# 2020 Corvette: Service Bulletin:: #20-NA-179: Malfunction Indicator Lamp (MIL) Illuminated - DTCs P0521 and/or P06DD Set - (Oct 23, 2020)

<b>Subject:</b>	Malfunction Indicator Lamp (MIL) Illuminated – DTCs P0521 and/or P06DD Set					
<b>Brand:</b>	<b>Model:</b>	<b>Model Year:</b>	<b>VIN Breakpoint:</b>	<b>Engine:</b>	<b>Transmi</b>	<b>ssion:</b>
		from      to	from      to			
Chevrolet	Corvette	2020	2020	SORP	September 10, 2020	6.2L (LT2)

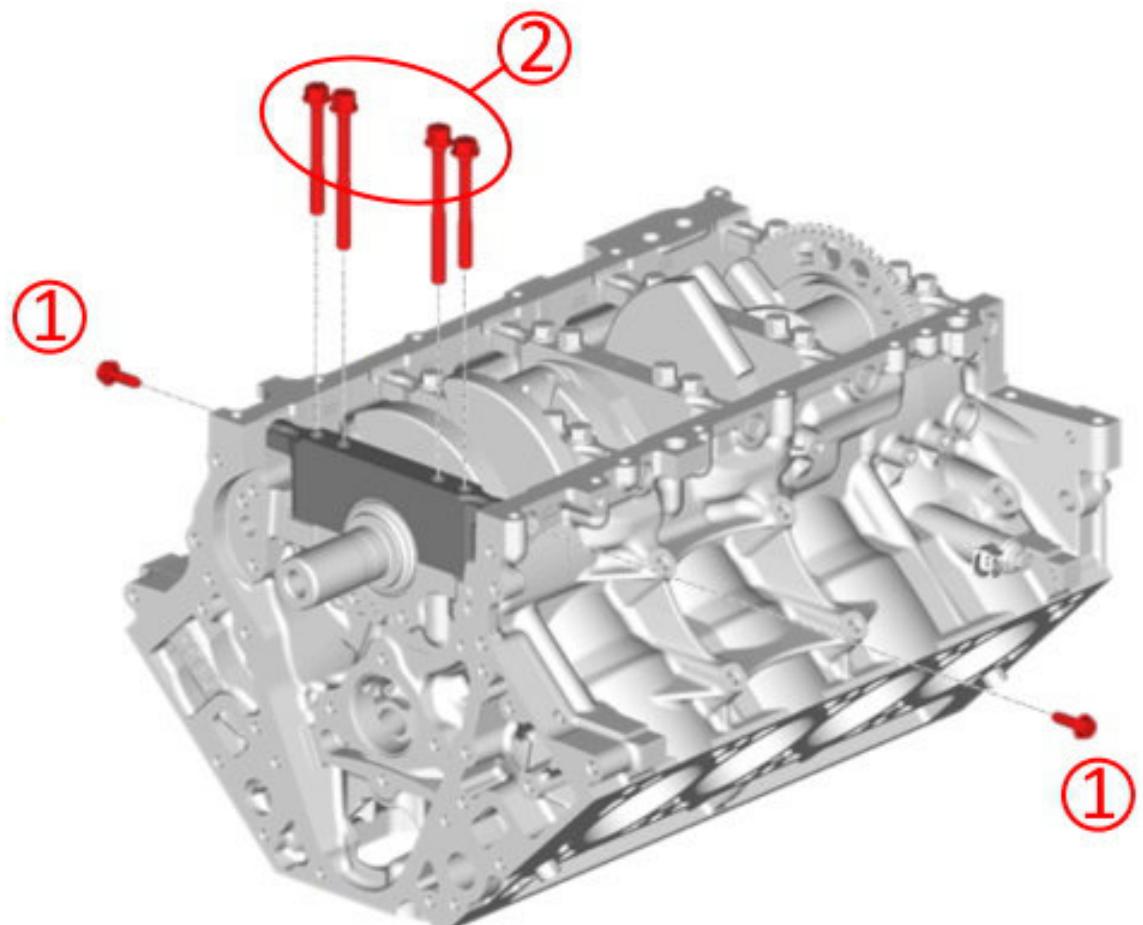
This condition may be caused by an unseated engine oil pressure control valve (OCV).

**Note:** If a vehicle comes in with one of these DTCs, follow SI for both DTCs to ensure there is not an electrical fault or other hardware concern. After diagnosis has been performed and no issues are found electrically, then it will be necessary to remove the engine oil pan and inspect for a unseated engine oil pressure control valve, which is mounted on the bottom of the engine oil pump.

If P0521 and P06DD DTCs are present, then a redesigned oil pressure control valve retainer clip (1) may be necessary. Refer to the Service Procedure section below.

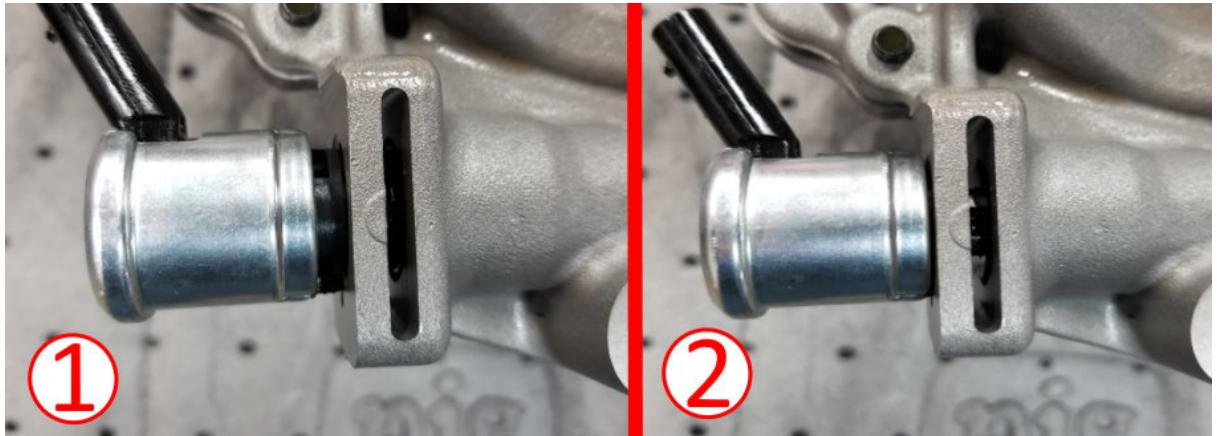
1. Remove the main cap side bolts (1).

**Important:** When removing the main bearing cap be careful not to

damage the main bearing or journal surface of the crankshaft. Please set the main bearing cap in a safe place so no debris or damage could occur.

1. Remove and discard the bolts (2) that secure the #1 main bearing cap.

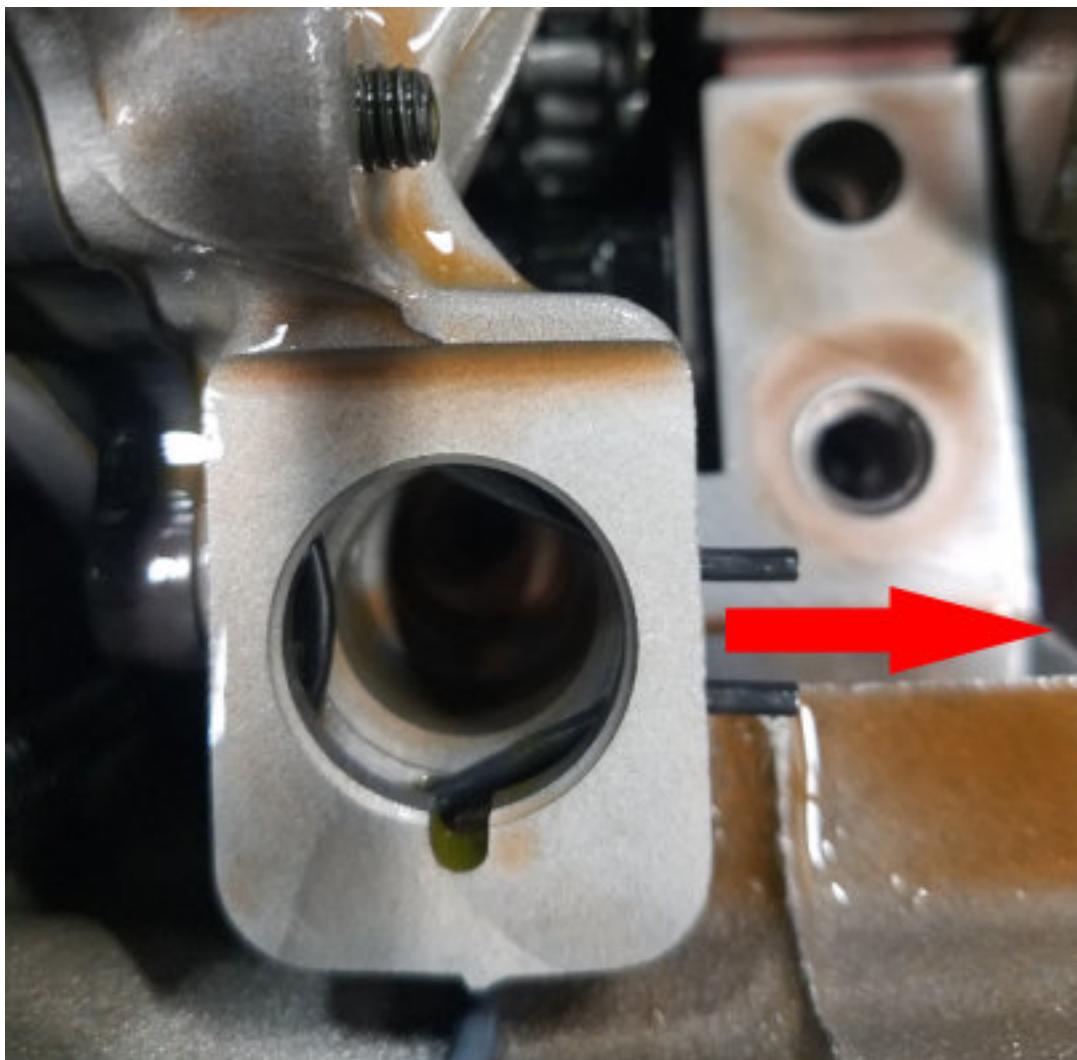
- If you find this oil pressure control valve dislodged (1), it will be necessary to install a redesigned oil control valve retainer.
- Disconnect the oil pressure control valve electrical connector and position aside.

**Note:** Remove the existing oil pressure control valve retainer by pulling towards the rear and discard. You will be installing a newly designed retainer during installation.

1. Push in the retainer and remove the oil pressure control valve and set aside.
2. Once the retainer is removed, inspect the oil pressure control valve for any signs of damage and ensure the O-ring is not cut.
  - Apply a small amount of clean engine oil to the pressure control valve and reinstall ensuring it is seated correctly.

**Important:** Do not use any tools to tap the pressure control valve into place. Only install the pressure control valve by pushing on the body of the valve by hand.

1. Install the new retainer from the front of engine towards the rear as shown in the graphic above.

1. When the retainer is installed, there should be about 2 to 3 mm of clearance between the retainer and the oil pump body as shown above.
